N057 UPS4717-1BNAS1

TECHNICAL BULLETIN

501-08: Exterior Trim and Ornamentation

Update Prior to Sale: Hood Finisher Detaching

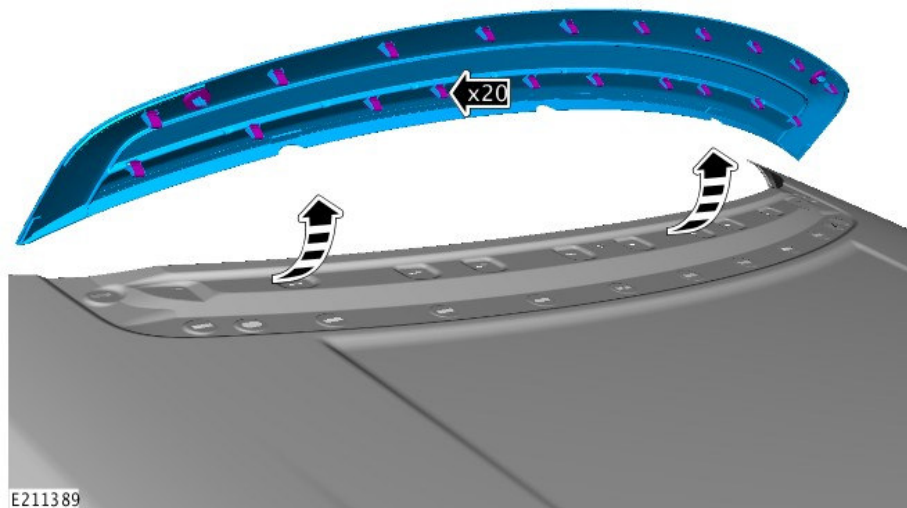
The hood finisher trim clips must be replaced.

Remove the hood finisher.

- 2 Remove and discard the 20 trim clips from the hood finisher.
- 3 Install 20 new trim clips to the hood finisher.

New hood exterior finisher trim clips must be fitted.

Install the hood finisher.
